ADDENDUM NO. 1

DATE: June 26, 2013

Contract 13-C-00033; Fire Station 19 Improvements

FIRE STATION 19
 7910 INTERBAY BLVD.
 TAMPA, FL

P-6.0

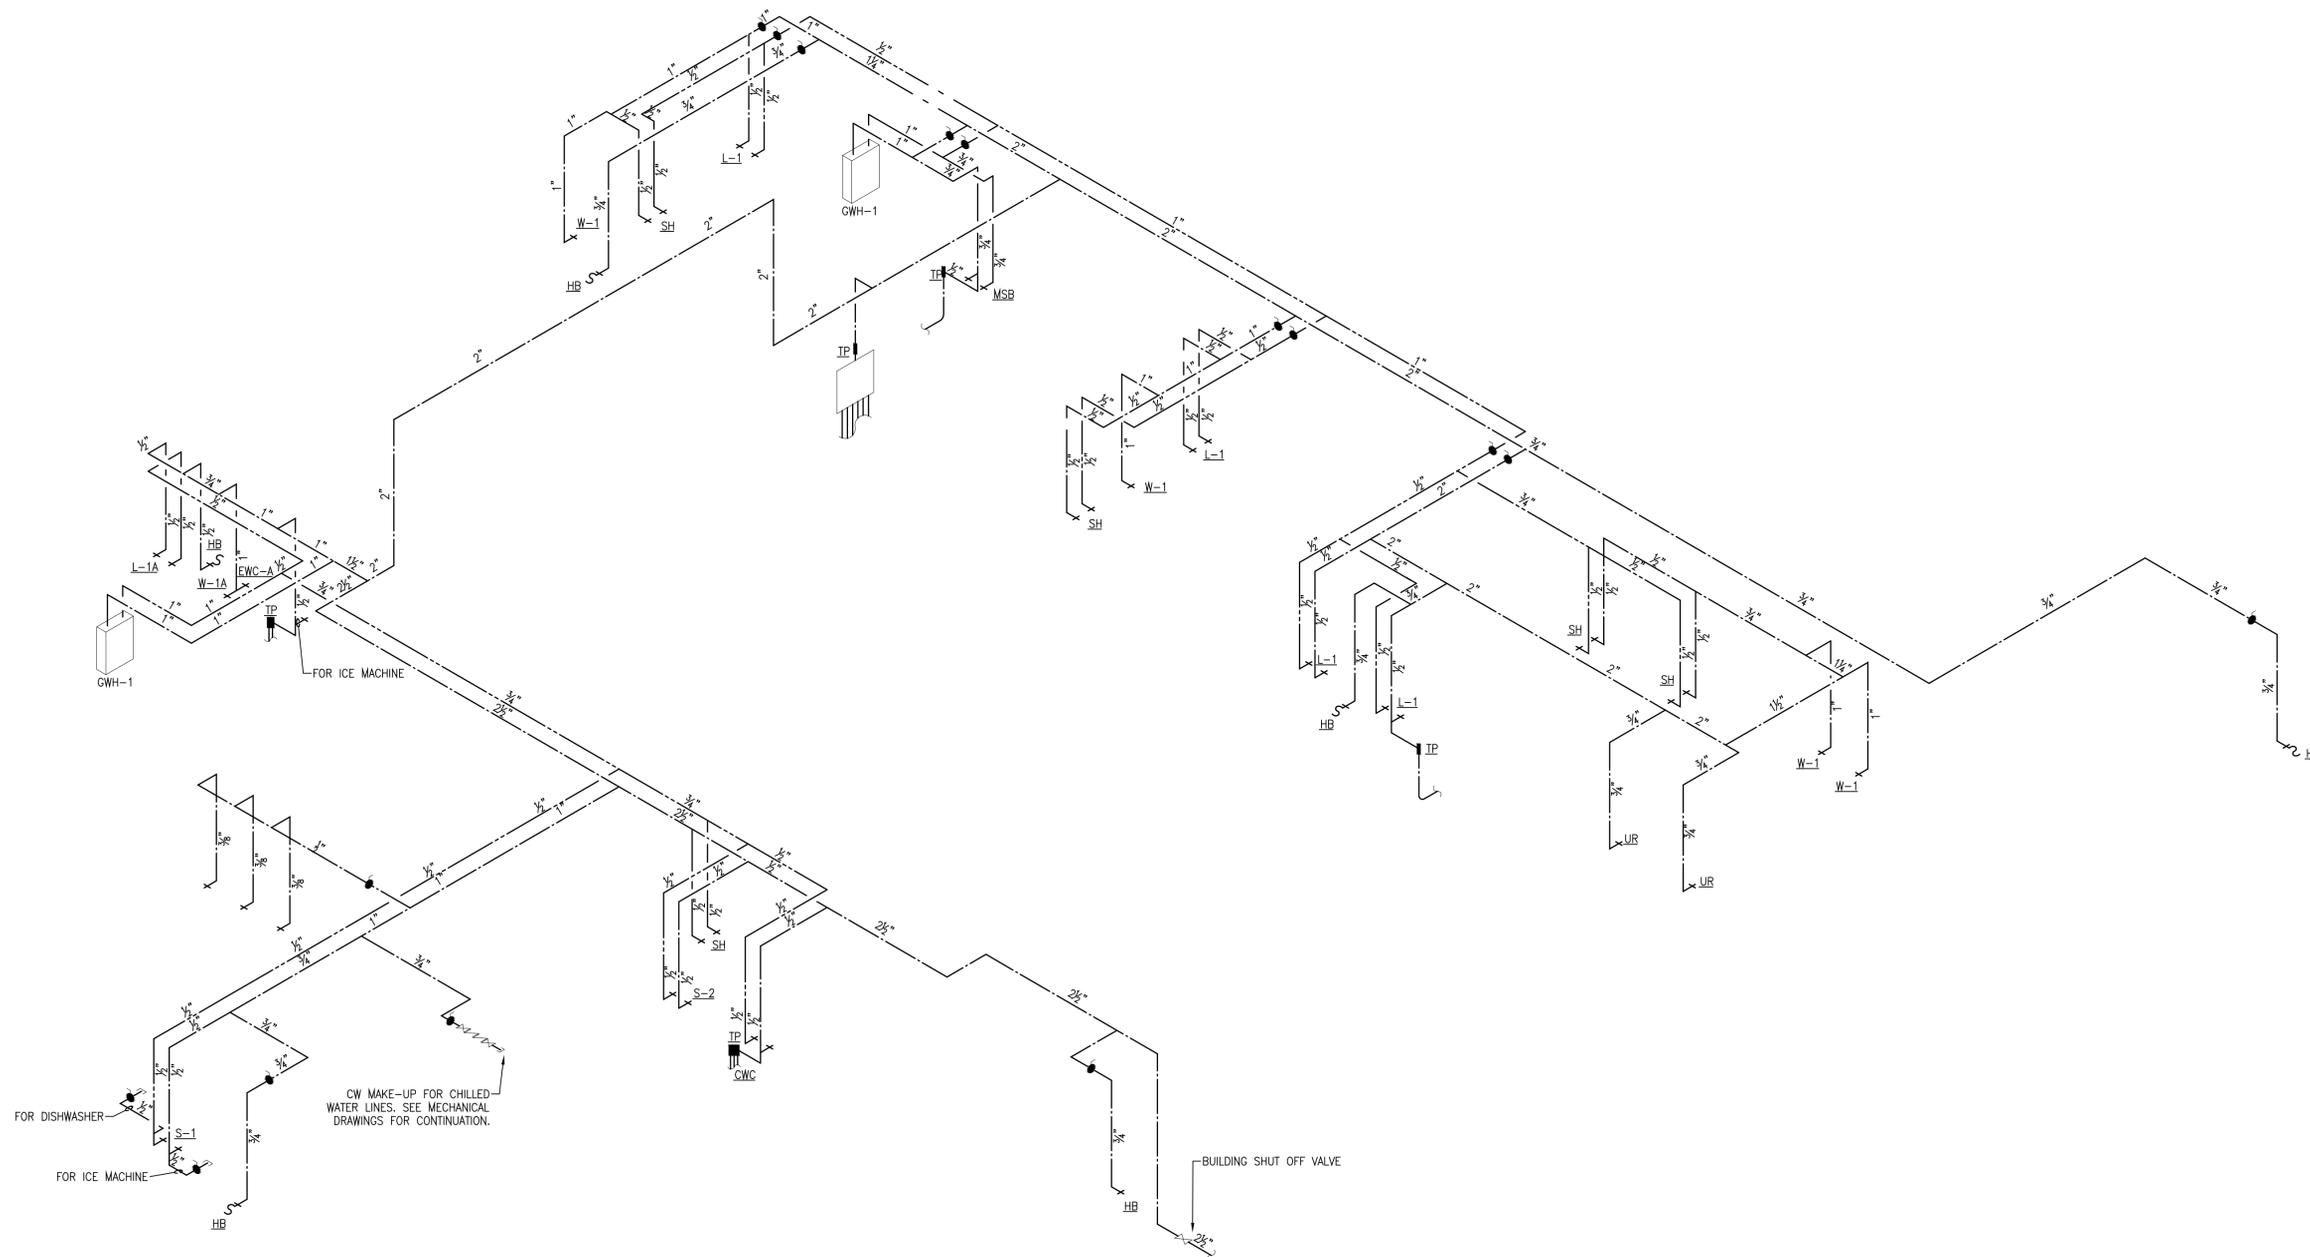
- Item 1: Permit and Utility Fee clarification: All fees are paid by the City.
- Item 2: Refrigerator Model Change: Bid basis is Kenmore 04641153000- Model #41153 (stainless steel)
- Item 3: Dryer Model Change: Bid basis is Kenmore 26-81372 White
- Item 4: Apparatus room ceiling height clarification: Ceiling is 18'-0" AFF.
- Item 5: Flag Pole height clarification: Flag Pole height is 35'-0".
- Item 6: Add plumbing sheet P-6.0
- Item 7: ARRA requirements Clarification: Delete all references. Contractor is encouraged to provide buy American products.
- Item 8: Dumpster Clarification: Replace Detail 2 on sheet C-1 with attached revised detail.
- Item 9: Sheet G-1, Index, Revise as follows: Delete sheet M-1.2 from Index.
- Item 10: Add the attached Electrical Sheet E-3.1.
- Item 11: Attached for your reference is the Pre-Bid meeting sign-in sheet.
